# Flat A, 45 Lancaster Grove (2015/2534/P)

<b>Delegated Report</b>		<b>Analysis sheet</b>		<b>Expiry Date:</b>		<b>07/07/2015</b>	
<b>(Members Briefing)</b>		N/A / attached		<b>Consultation Expiry Date:</b>		02/07/2015 22/10/2015 21/12/2016	
<b>Officer</b>				<b>Application Number(s)</b>			
Elaine Quigley				2015/2534/P			
<b>Application Address</b>				<b>Drawing Numbers</b>			
Flat A, 45 Lancaster Grove London NW3 4HB				See draft decision notice			
<b>PO 3/4</b>		<b>Area Team Signature</b>		<b>C&amp;UD</b>		<b>Authorised Officer Signature</b>	
<b>Proposal(s)</b>							
Excavation of basement extension to the rear (retrospective) and erection of ground floor rear extension above all in connection with existing flat (Class C3).							
<b>Recommendation(s):</b>		Grant condition planning permission					
<b>Application Type:</b>		Full Planning Permission					
<b>Conditions or Reasons for Refusal:</b>		Refer to Draft Decision Notice					
<b>Informatives:</b>

**Diagram 5:**

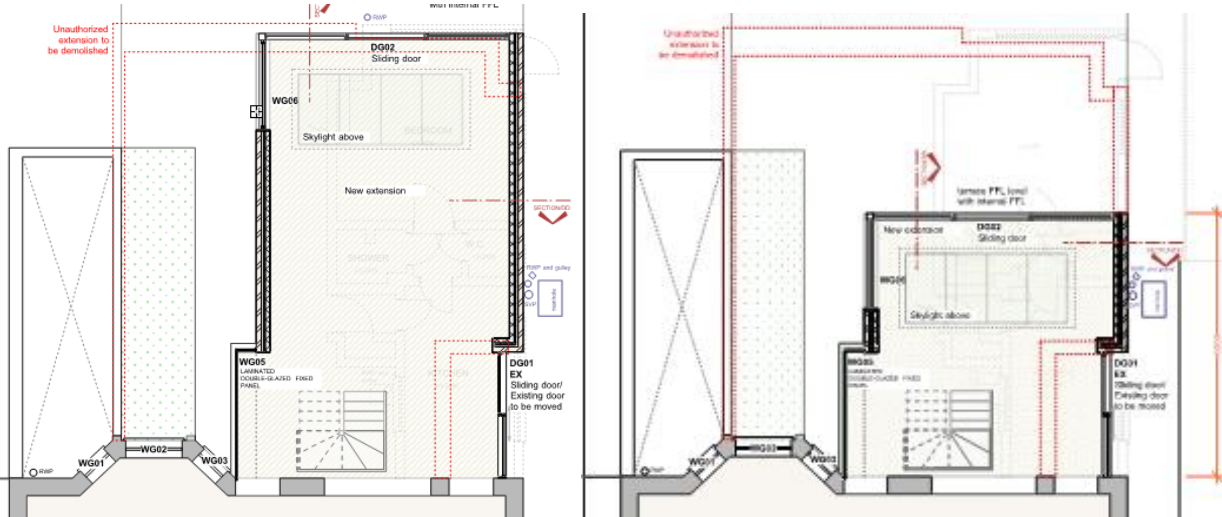
- The length of the extension at nearly 10m was not considered to address the issue of the excessive scale and mass of the ground floor extension and was considered harmful to the character and appearance of the building and the conservation area. Revised drawings were submitted showing a reduction in its length from 9.97m to 6m (see diagram 5 below)

3.6 Consequently revised drawings were submitted reducing the length of the extension from approximately 10m to 6m from the main rear façade of the building. .

**Diagram 6:**

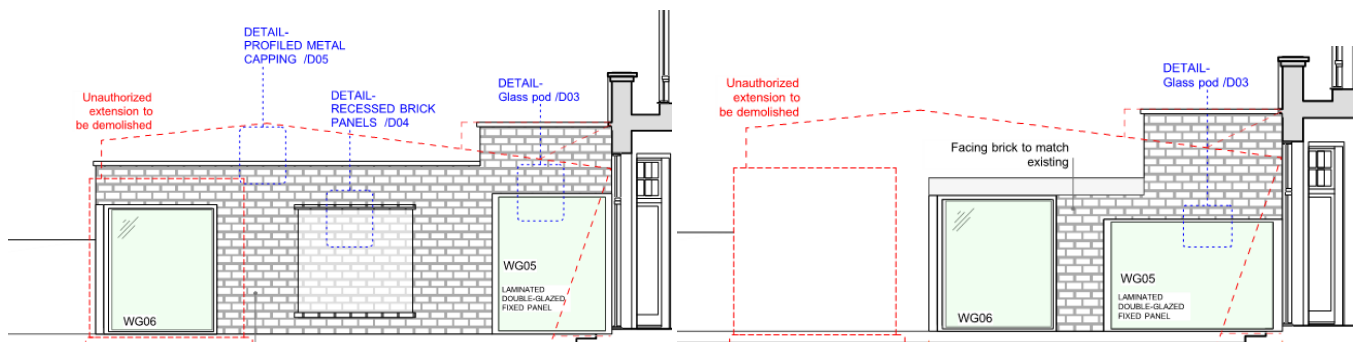
- Following comments raised during the consultation period and following further assessment of the application it was considered that the height of the single storey rear extension projecting beyond the rear elevation of no. 47 was too high and would impact on the amenity of the neighbouring occupier at no. 47 in terms of sense of enclosure. The applicant revised the drawings to reduce the height of the part of the extension that projects beyond the rear boundary of no. 47 from 3.2m to 2.75m (see diagram 7 below)

3.31 In the 2012 scheme the extension measured 3.8m at its highest point and was 1.2m from the shared boundary with no. 47. The proposal has been revised during the course of the application to reduce the height of the extension that projects beyond the rear elevation of no. 47. It now measures 2.75m in height and would be 1.2m from the shared 1.8m high boundary fence with no. 47. The reduction in the height of the proposed extension together with the reduction in the length of the extension (3.6m beyond the rear elevation of no. 47) ensure the extension would not unduly dominate the rear room and garden of this property and would retain an acceptable level of outlook.
